CITY OF ST. HELENS PLANNING DEPARTMENT
STAFF REPORT
Conditional Use Permit CUP.2.23; Variances V.1.23, V.2.23, and V.3.23

DATE: March 14, 2023
TO: Planning Commission
FROM: Jacob A. Graichen, AICP, City Planner

APPLICANT: James Casey McGuirl of McGuirl Designs & Architecture
OWNER: La Grand Townhomes, LLC

ZONING: Mixed Use, MU and General Residential, R5
LOCATION: 4N1W-4AA-600; NW corner of Columbia Boulevard/N. 6th Street intersection; Lots 20-22, Block 60, St. Helens Subdivision
PROPOSAL: Mixed use development consisting of 9 dwelling units and up to three commercial suites, all within a single three-story building.

SITE PLAN

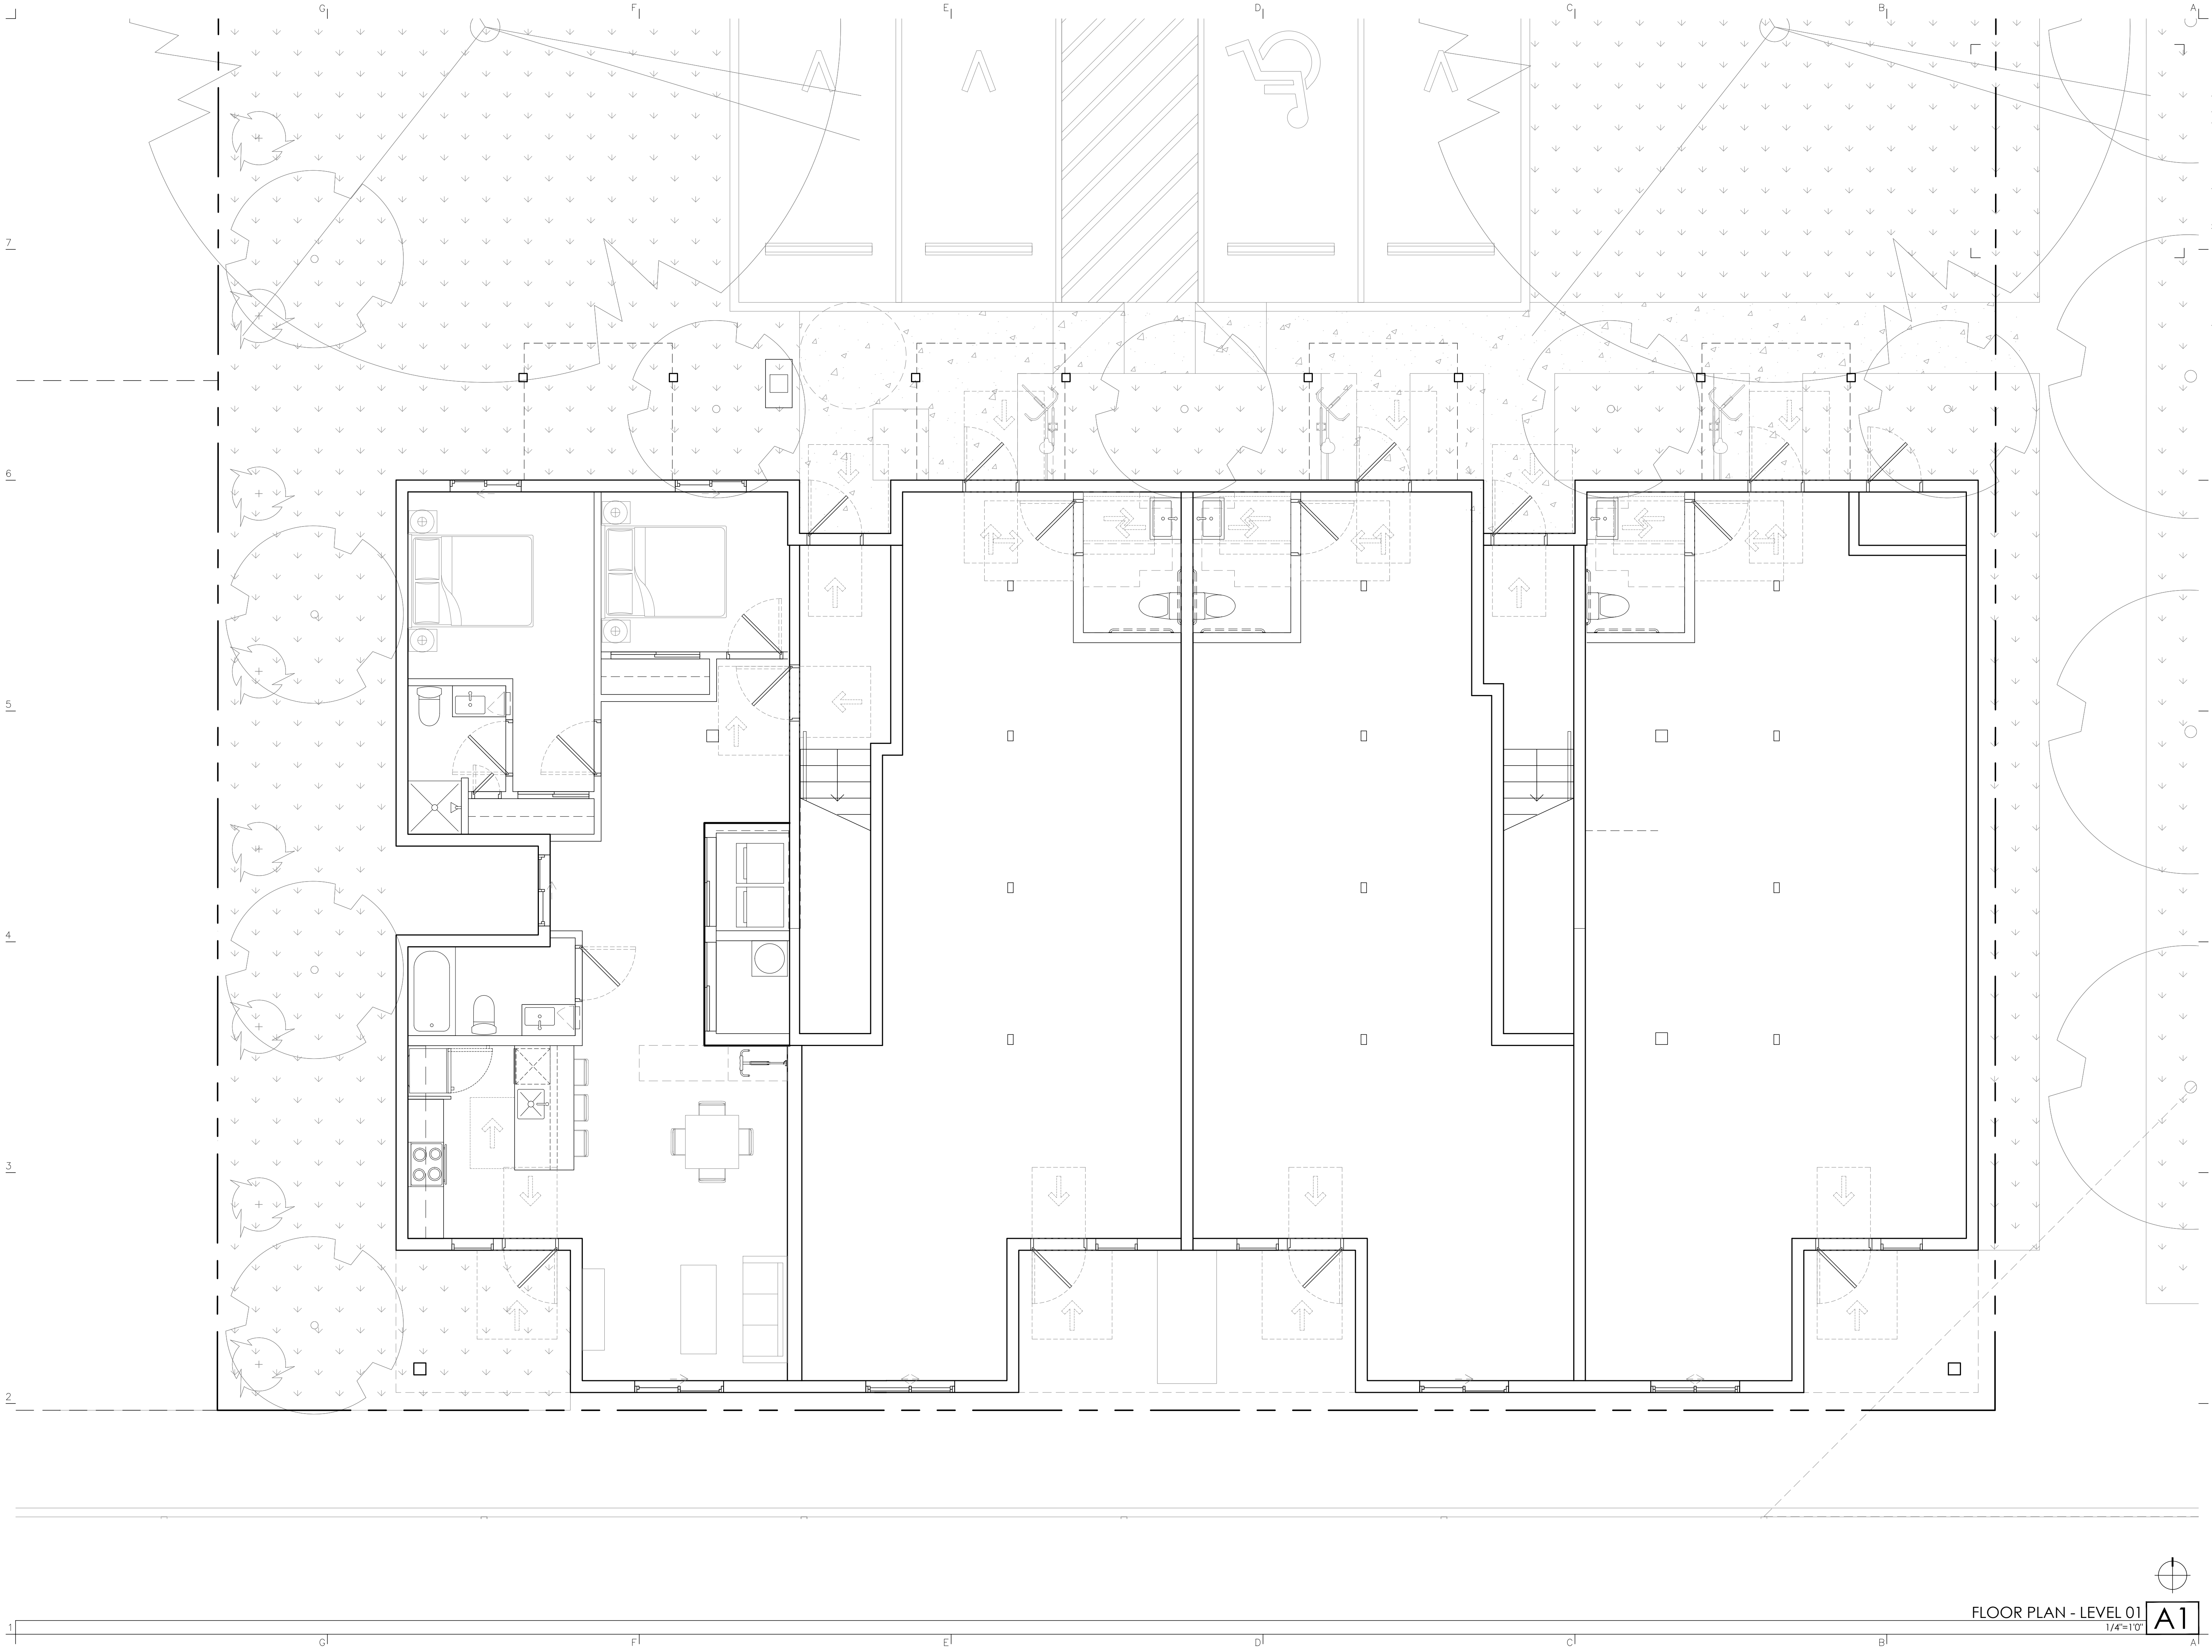
There is a tree shown in close proximity to an existing utility pole along N. 6th Street. Features like utility poles will need to be included on the plans for proper tree layout.

A trash enclosure is shown on the site plan but there are no elevation details (e.g., to show fence/wall height. Details needed as part of final plans.

21 spaces are proposed, leaving three spaces for the to-be-determined non-residential use(s). Approximately 3,000 square feet of commercial gross floor area is proposed. This leaves 1 space per 1,000 square feet, which is inadequate for most possible non-residential uses per SHMC 17.80.030. If there were 8 spaces for non-residential, it would be one space per 350' square feet of area, which accommodates most possible uses, generally. **So, what about the 5 spaces that do not exist?**

three to four on-street parking spaces would be possible along Columbia Boulevard—parallel spaces are 22' long (plans show lesser lengths).

Given the proposed driveway and maintaining vision clearance, there is likely less opportunity for on-street parking (even though it is the longer side) along N. 6th, but it is reasonable to assume three properly sized spaces (parallel spaces are 22' long and plans show lesser lengths).

4'+ wide concrete walkways are proposed. Walkway to ground level residential unit is unclear. Lighting plan will be necessary.

- A. Per condition 4.
 - B. Trash enclosure details.
 - C. Show how each dwelling unit will have one lockable bicycle space under covered and per all other provisions of the Development Code.

- D. Signage/markings plan for the parking lot to include direction arrows, striping, and how designated spaces (e.g., visitor and compact parking) will be labeled.

- E. Each residential dwelling shall be connected by walkway to the vehicular parking area, and common open space and recreation facilities. Walkway to ground level residential unit was unclear in the plans submitted for land use approval.

**FLOOR PLAN -
LEVEL 01**

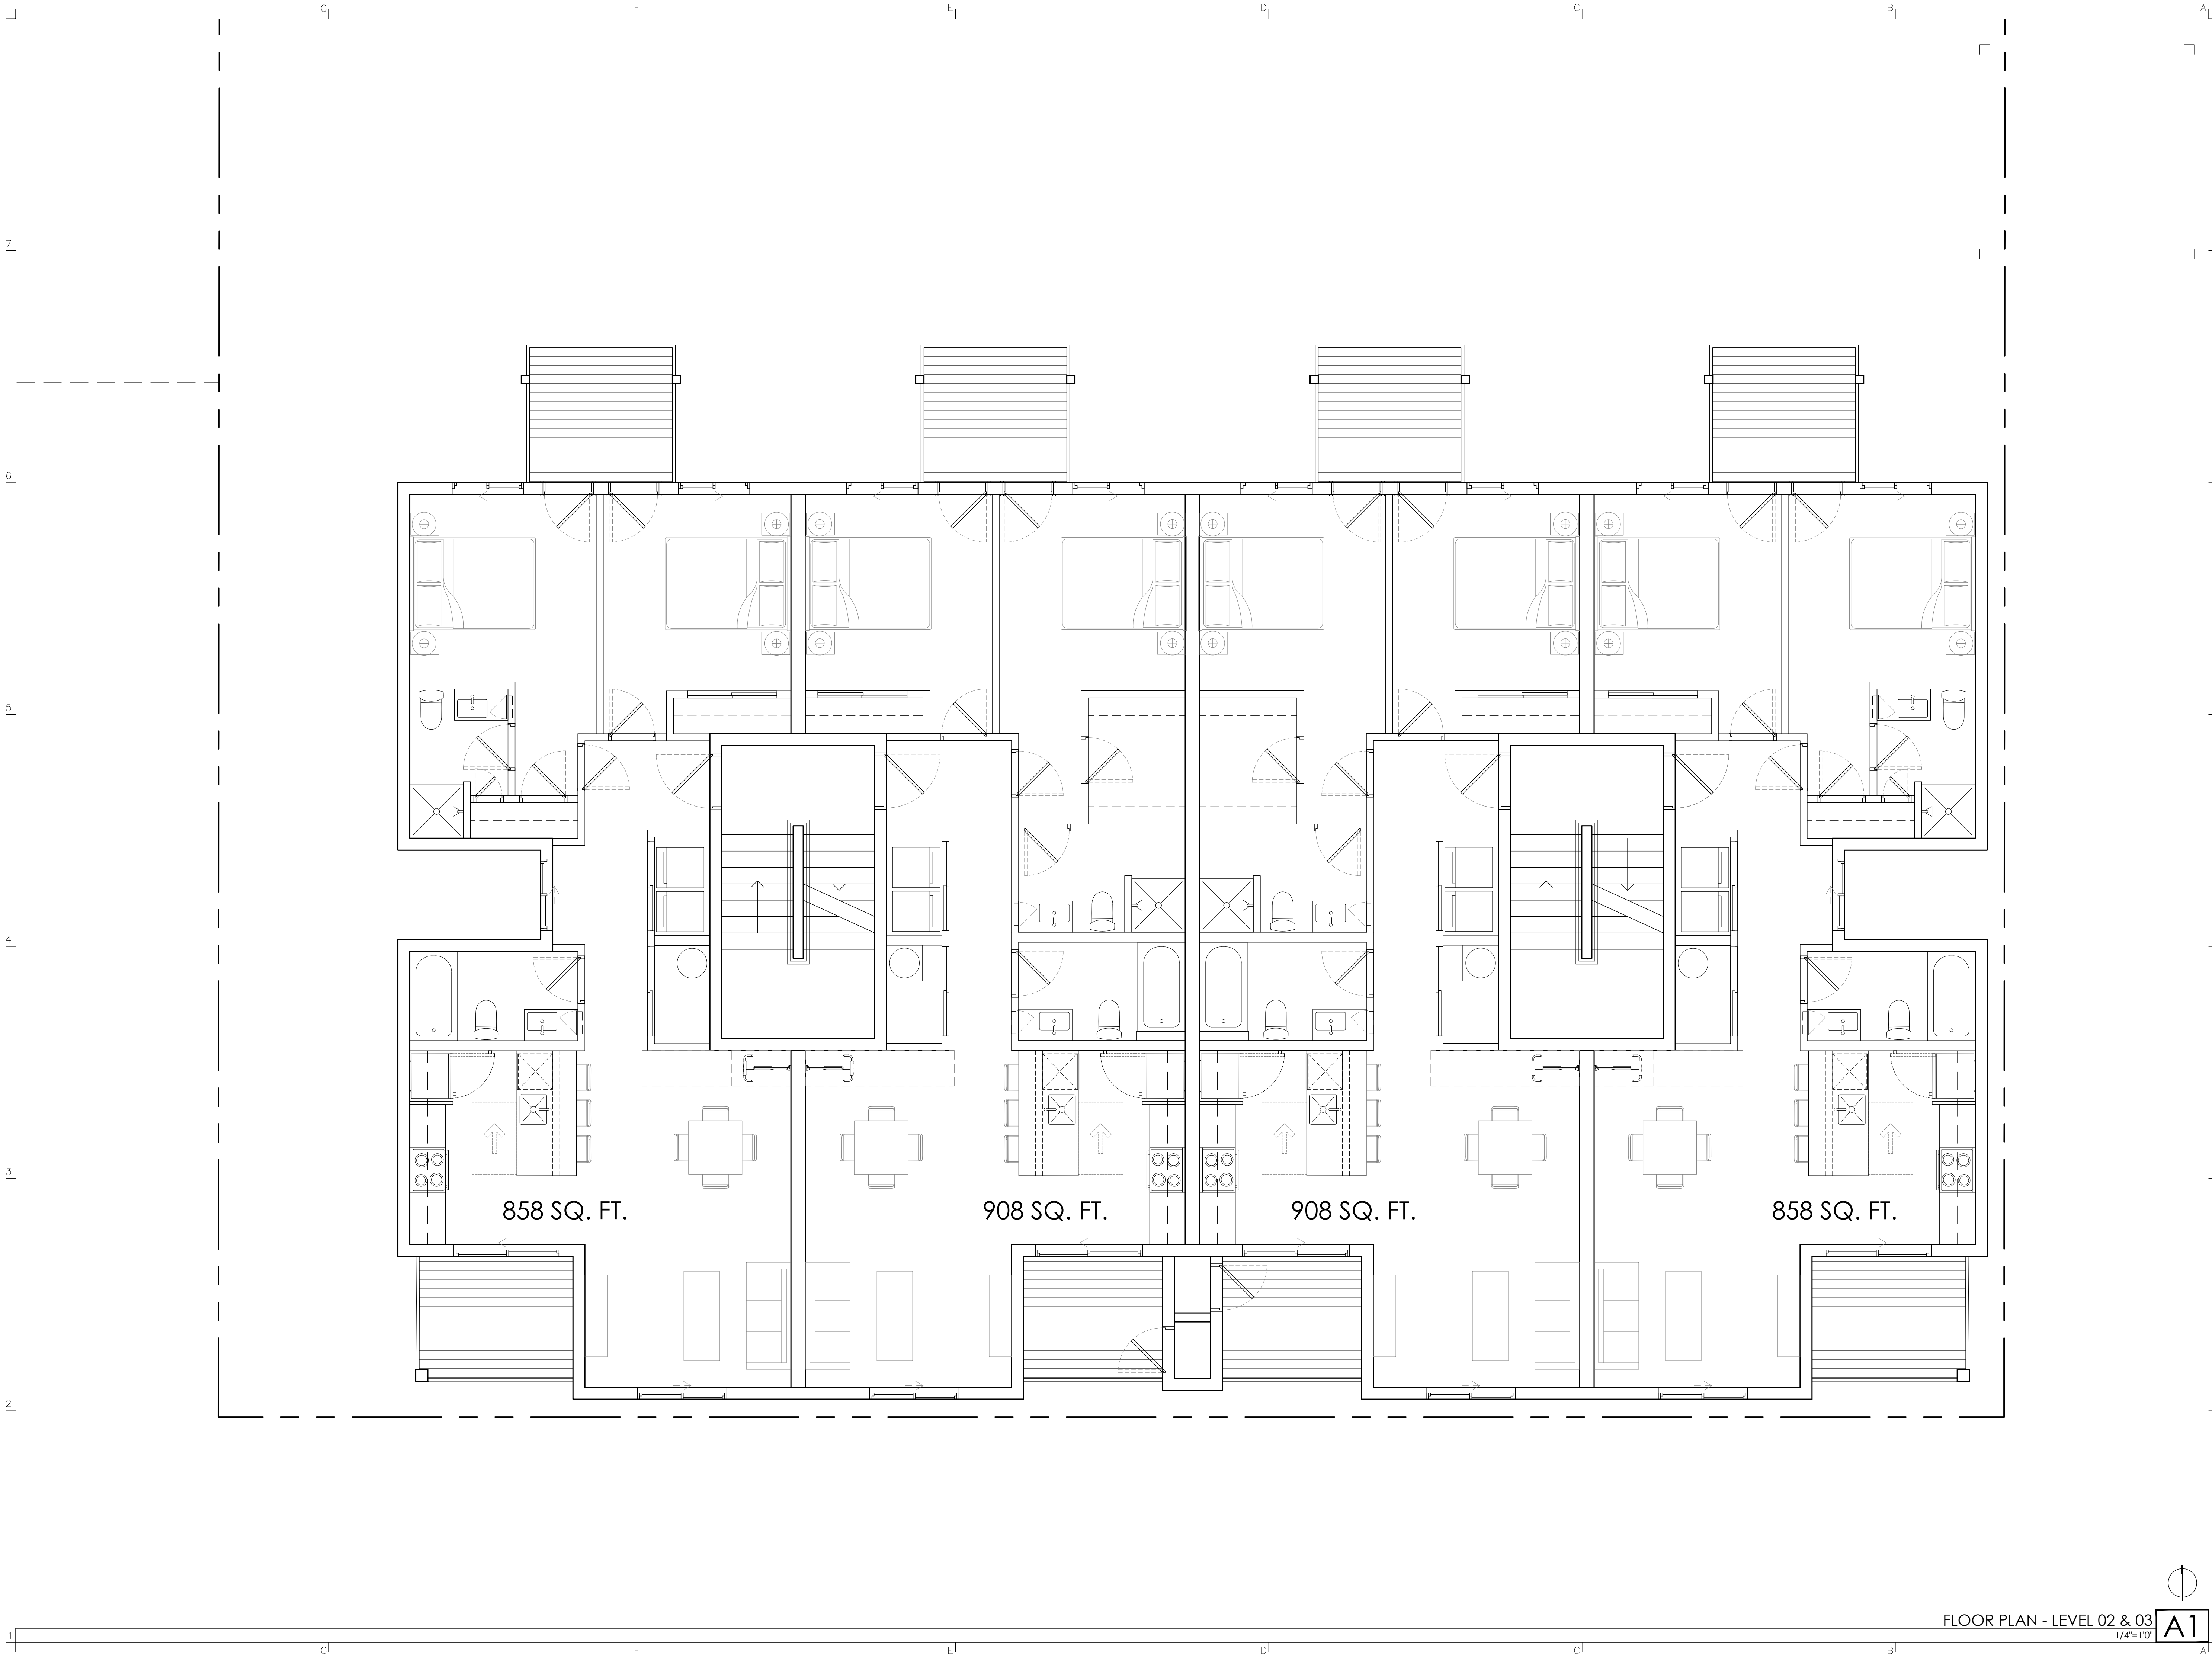
(a) The ground level unit has the most direct access to on-site open space. Only one door for the unit facing Columbia Boulevard (south elevation) is proposed. **A door on the north or west elevation could provide better quality access and should be a consideration of the Commission.**

There are windows on all sides of the building, though the west side glazing is scant and the sole windows for dwelling units on this side are recessed. **The Commission should consider additional windows and/or ensure this area is illuminated as part of the lighting plan that will be required.**

FIGURE
7-2

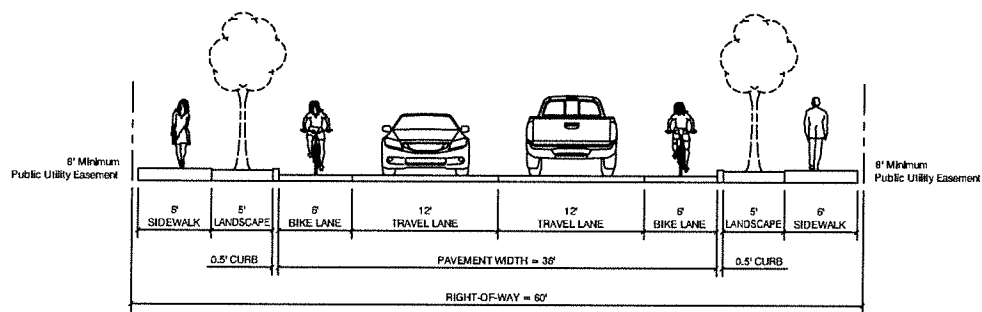
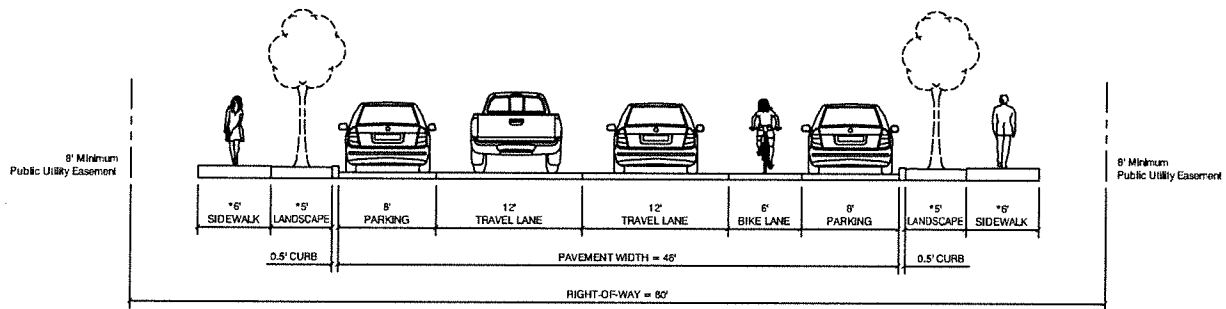
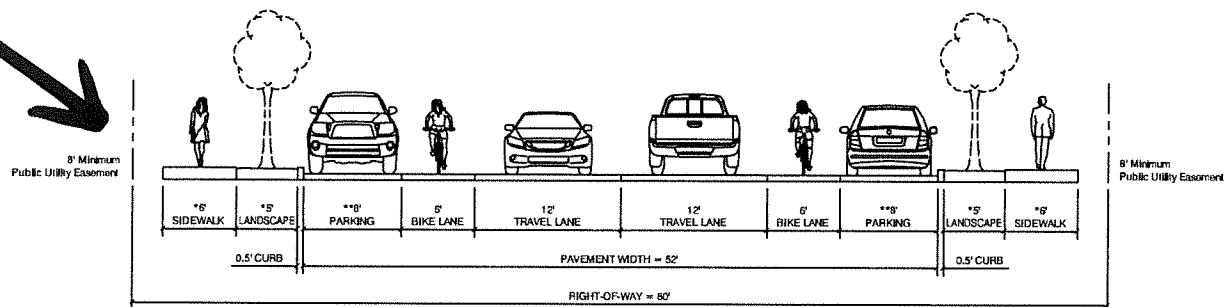
The plans show on-street parking. Both Columbia Boulevard and N. 6th Street is classified as minor arterial streets, which based on their *typical* Transportation Systems Plan standard, do not include on-street parking (**see attached TSP Figure 7-2**).
